# PLANNING DIVISION

## GENERAL APPLICATION

Location Address: 3255 Hollywood Blvd, Suites 1 and 2

HOLLYWOOD HILLS PLAZA OUTPARCEL  
FINAL TAC SUBMITTAL

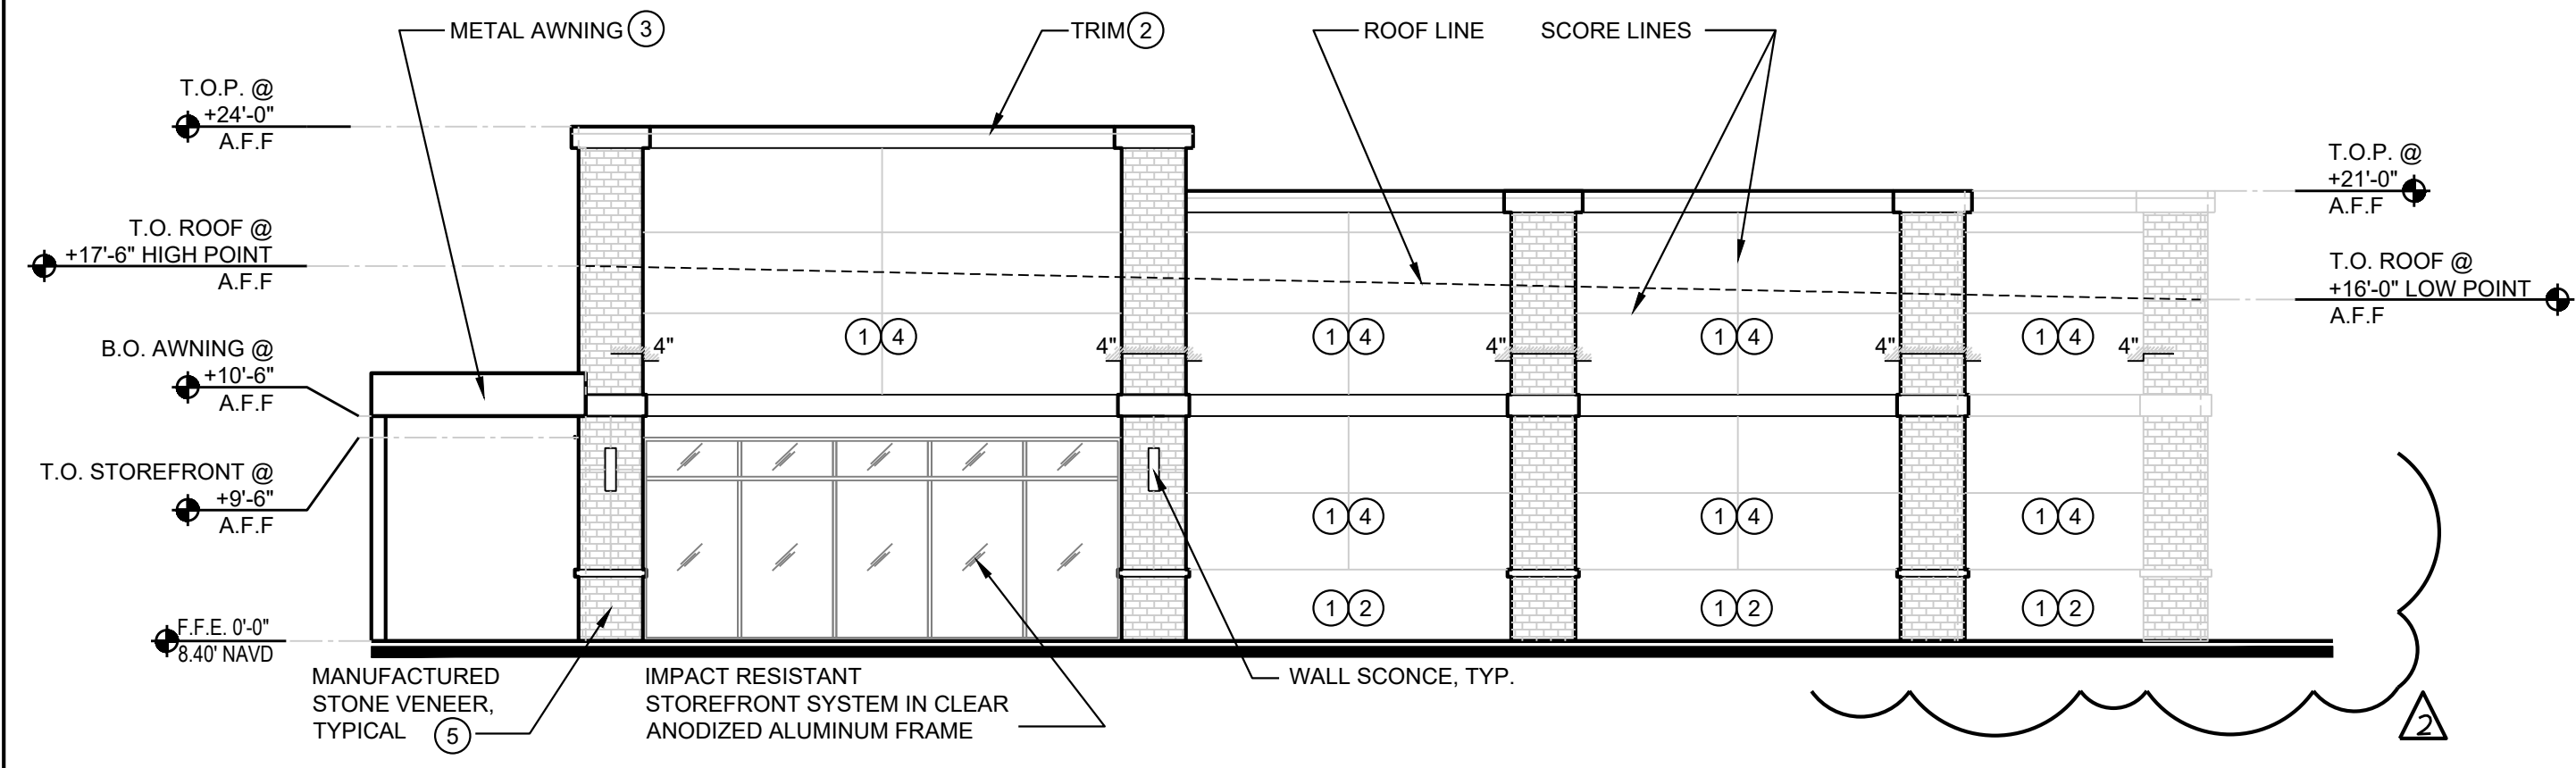
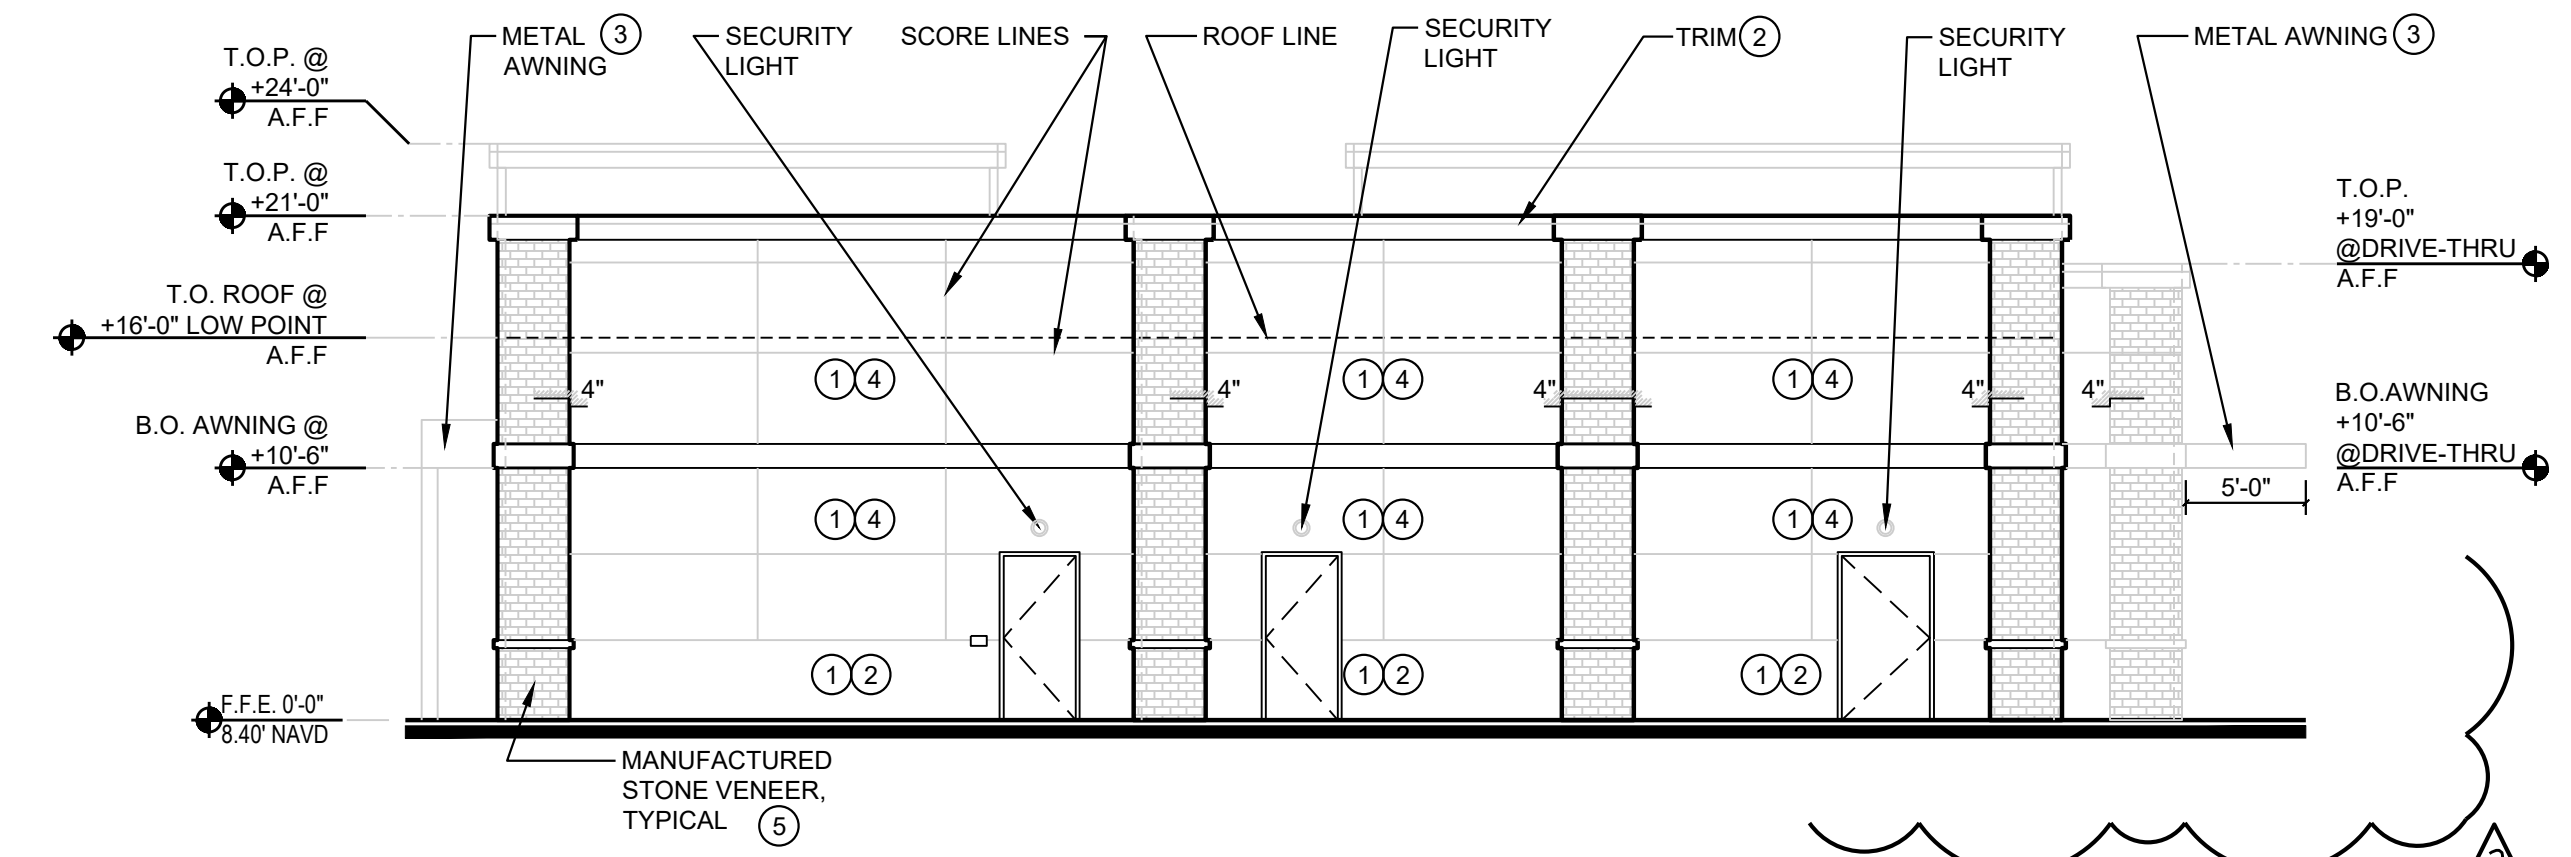
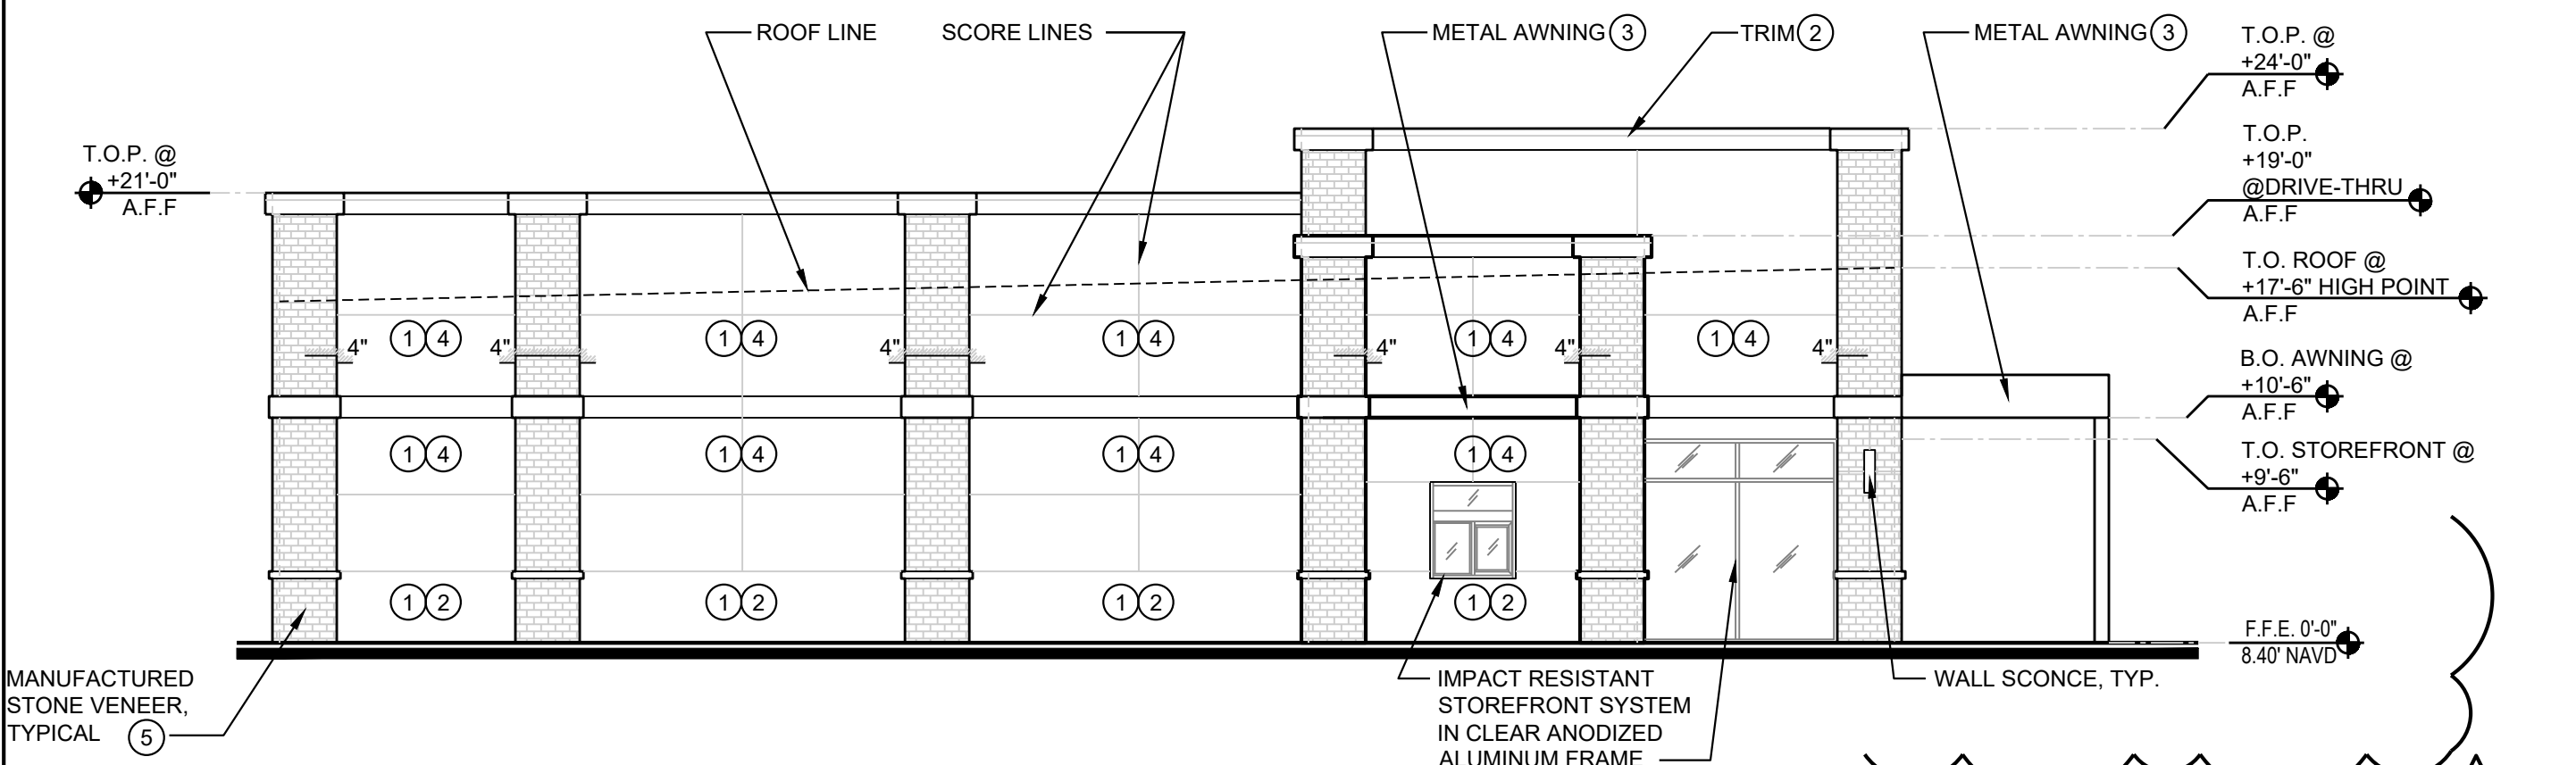
1. Comment: Given the outparcel's location within a shopping complex, the project should incorporate addition architectural articulation on the north and west facades.  
**Response:** *The elevations have been revised as requested. Please refer to sheet A1.0.*
